PROJECT: Summerlin V23B Phase 1 V(Carpis + rano)

SUBMITTAL: 1st

CITY OF LAS VEGAS		DATE:
INTER-OFFICE MEMORANDUM		September 12, 2013
TO: Land Development Services Department of Building & Safety		FROM: Albert Sung, P.E. Flood Control Project Engineer Department of Public Works
SUBJECT:	Drainage Study for:	COPIES TO:
	Summerlin V23B Parcel V (Capistrano)	VTN Nevada
Cross Streets:	NEQ of Sky Vista Drive & Alta Drive	Ryland Homes Nevada, LLC
File Number:	F:\Depot\DSMemos\DS4623A.doc	Bart Anderson, P.E., DevCo
Parcel Number:	137-34-111-003	CCRFCD
Zoning Action:	TMP-50117	
FEMA Flood Zone	YES	NO X
Proposed Storm Drain	YES	NO X

The Drainage Study for the subject project has been reviewed and:

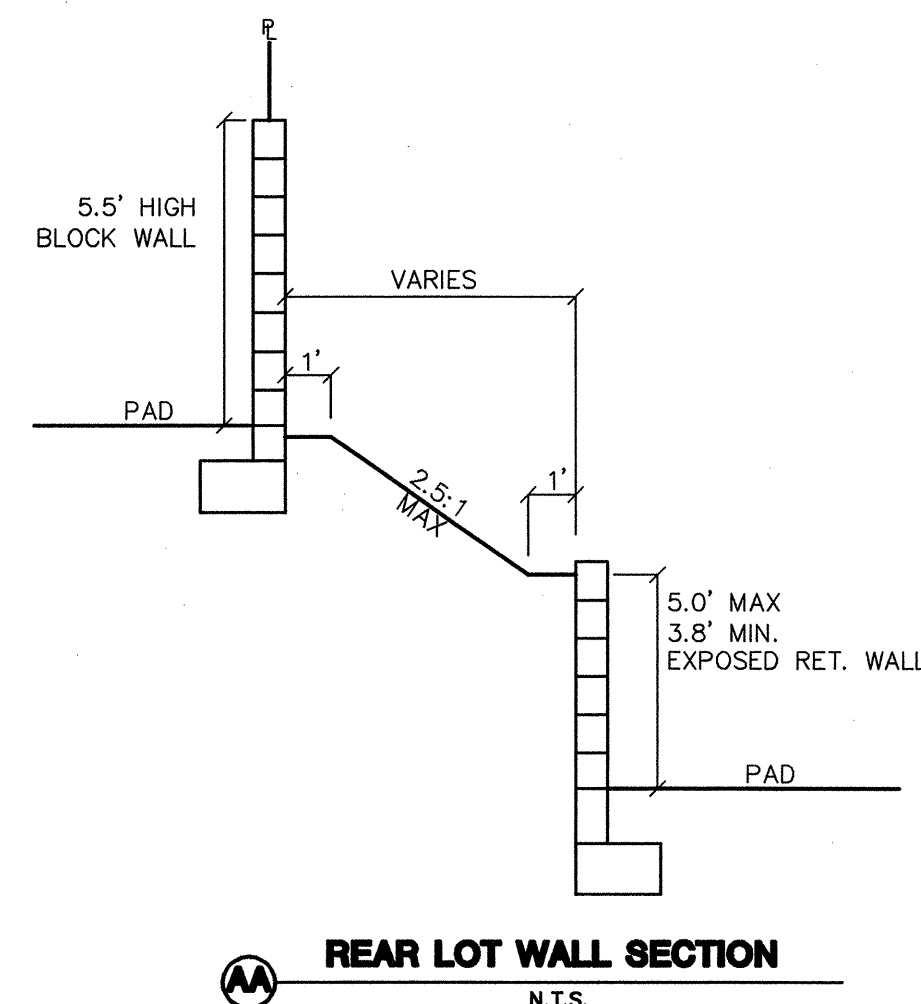
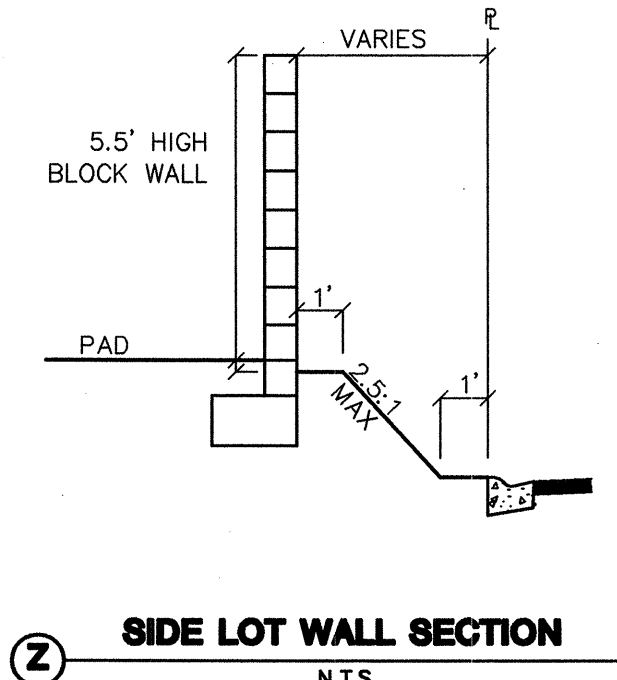
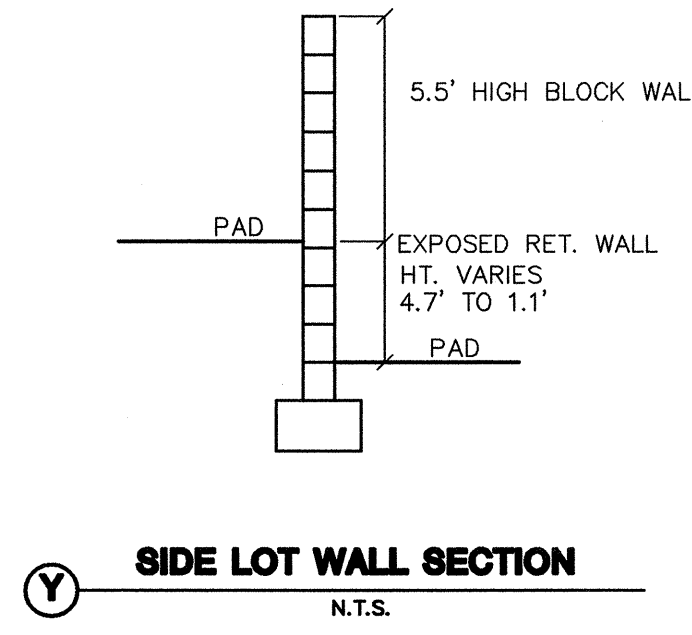
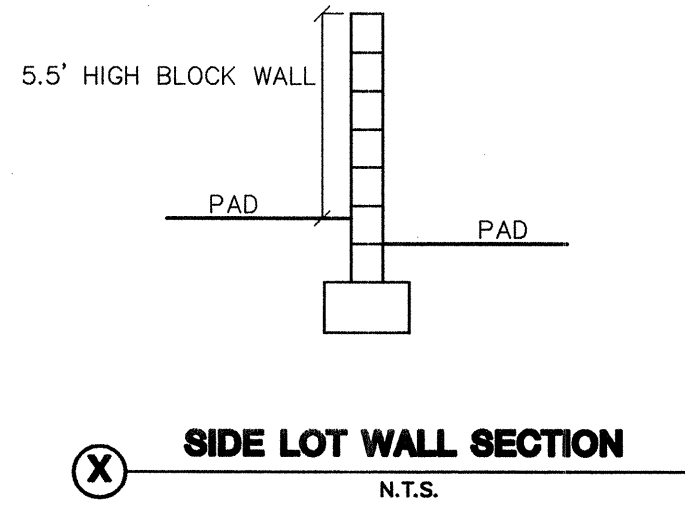
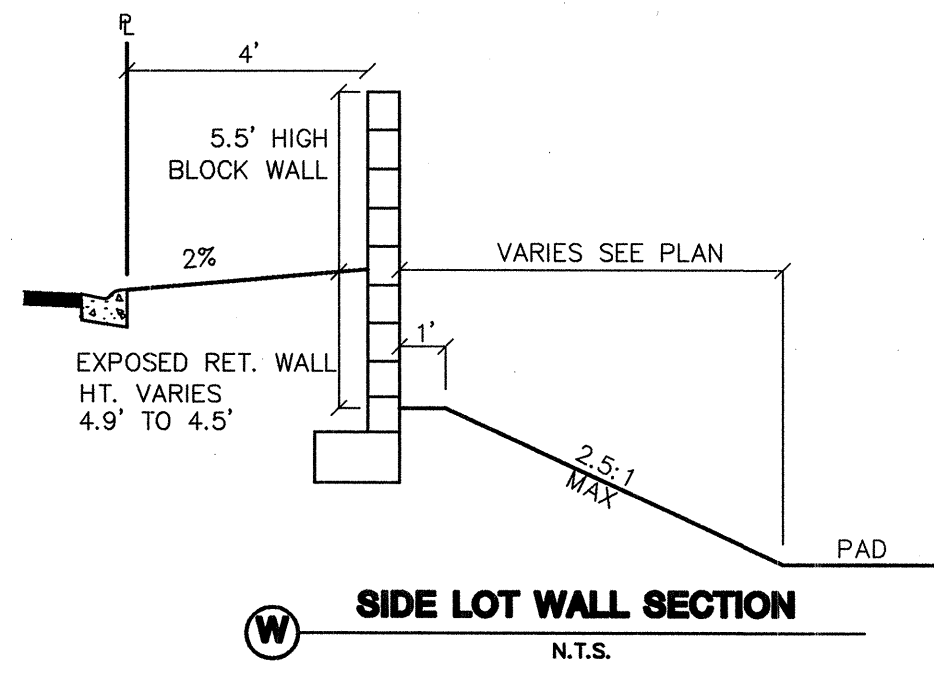
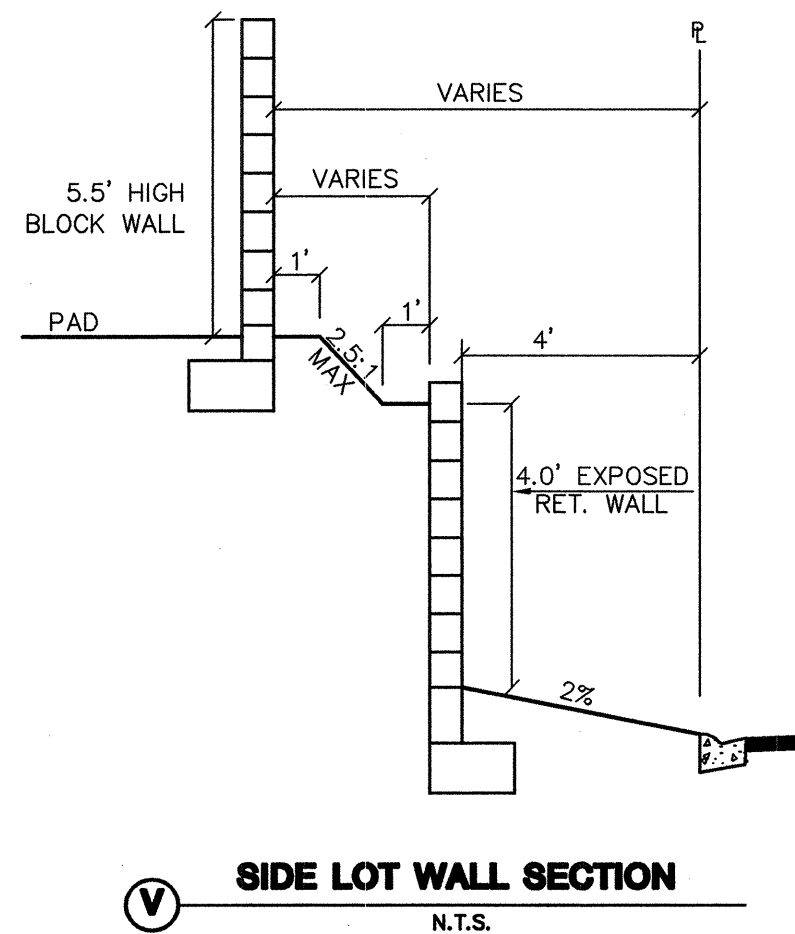
10. **Sheet DT1:**

- **Detail Sections H, I, J and K:** The bottom three courses of the wall adjacent to the street must be 8"-CMU and to be solid grouted.
